Topic

For more stable unit use, the electronic safety temperature limiter eSTL with software version V 5.04 is now available from service parts. Units ex works are currently equipped with software version V 1.03 (remaining stock) or software version V 5.04.

This applies to the following eSTLs:

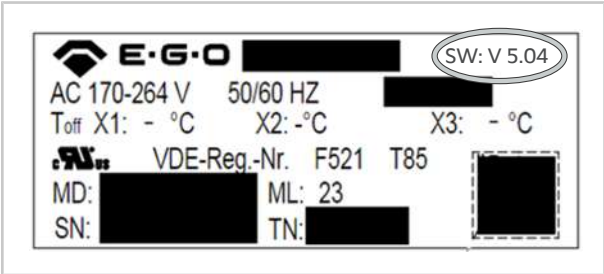
If the input voltage exceeds or falls below the specified frequency, the eSTL automatically resets with software version V 5.04. This behaviour is identical when the input voltage is exceeded or dropped below.

If the frequency of the input voltage is permanently exceeded or dropped below, the automatic reset is time-limited. After 24 hours, the mains supply must be checked for frequency fluctuations and the eSTL must be manually reset by a RATIONAL technician.

It is not necessary to actively replace the installed eSTLs, as they continue to protect against overtemperature.
